ADDENDUM #1 – August 24, 2015

WEST VIRGINIA PARKWAYS AUTHORITY

**BRIDGE RETROFIT
CONTRACT BR-1-15
KANAWHA COUNTY**

Remove and replace in contract plans:

WEST VIRGINIA TURNPIKE
CONTRACT BR-1-15
**GENERAL NOTES, QUANTITIES
AND INDEX OF SHEETS**

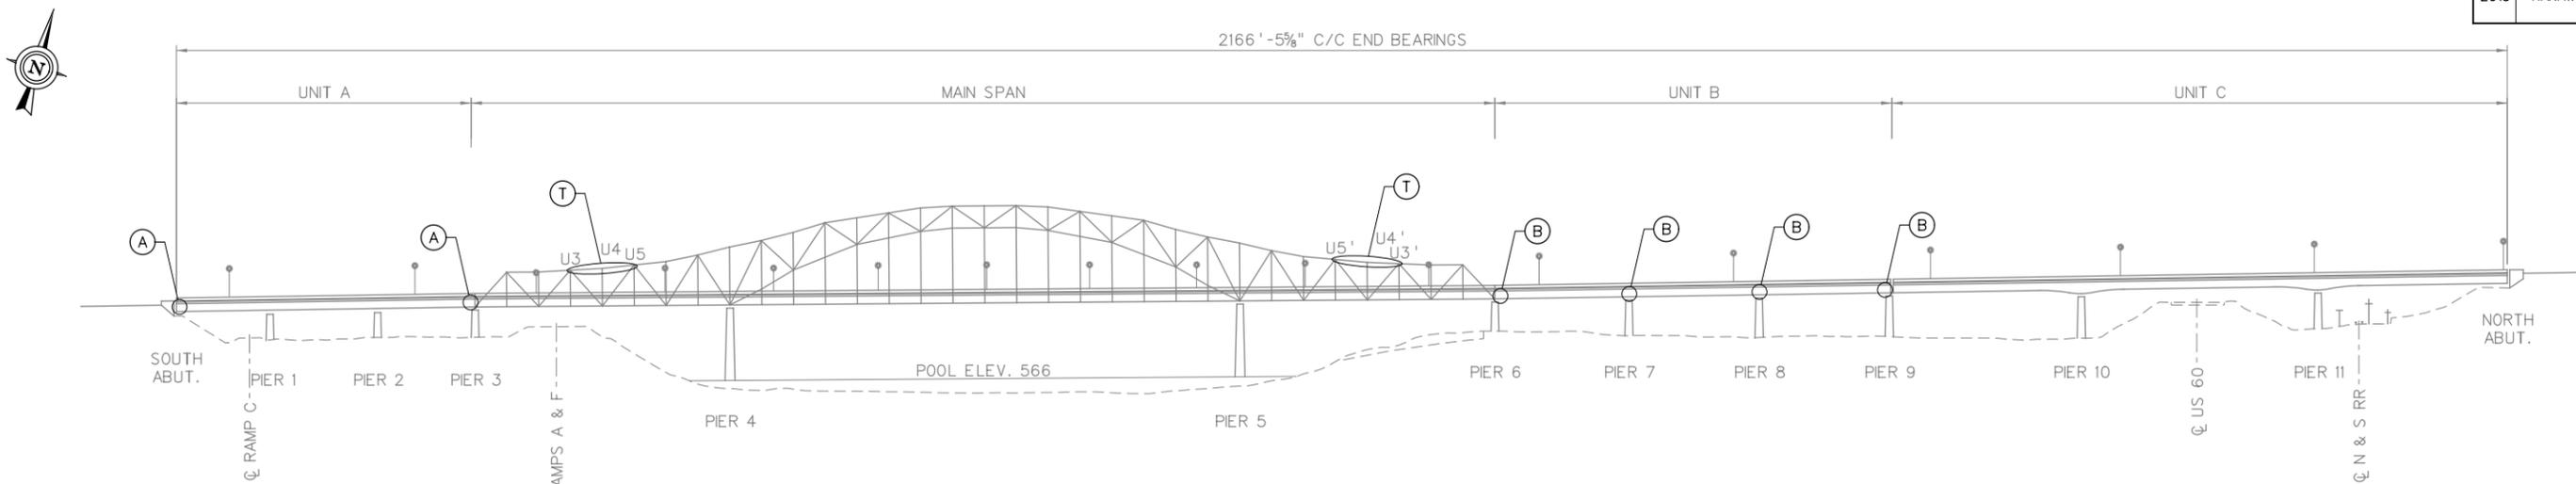
- Sheet 2 – Revised Structural Steel and Paint Note
- Sheet 14 – Revised Notes and Sketch

ALL STRUCTURAL STEEL SHALL CONFORM TO AASHTO M270, GRADE 36 OR GRADE 50, UNLESS OTHERWISE NOTED. ALL FASTENERS SHALL BE 3/8" DIAMETER AASHTO M164 (ASTM-A325) HIGH STRENGTH BOLTS, UNLESS OTHERWISE NOTED. ALL STRUCTURAL STEEL AND HIGH STRENGTH BOLTS SHALL BE INCIDENTAL TO ITEM 615003-001. THE USE OF HOT DIPPED GALVANIZED BOLTS SHALL BE PERMITTED.

ALL NEW STRUCTURAL STEEL SHALL BE SHOP PRIMED IN ACCORDANCE WITH SUBSECTION 711.20. SHERWIN WILLIAMS ZINC CLAD III HS, INORGANIC ZINC-RICH COATING AT 3.0-5.0 MILS DRY FILM THICKNESS APPLIED EVERYWHERE, OR APPROVED EQUAL.

ALL NEW STRUCTURAL STEEL SHALL RECEIVE A UNIFORM COAT OF SHERWIN WILLIAMS ACRYLON 218 HS ACRYLIC POLYURETHANE FINISH COAT AT 3.0-6.0 MILS DRY FILM THICKNESS APPLIED EVERYWHERE. TOP COAT COLOR TO BE DARK GREEN, FEDERAL STANDARD 595 NUMBER 14062. THE PAINT SYSTEM USED WILL BE SHERWIN WILLIAMS OR APPROVED EQUAL.

IF CONTRACTOR ELECTS TO USE ALTERNATE PAINT SYSTEM DURING NIGHTTIME OPERATIONS; THE CONTRACTOR SHALL SUBMIT PRODUCT DATA SHEETS TO ENGINEER FOR REVIEW AND APPROVAL.
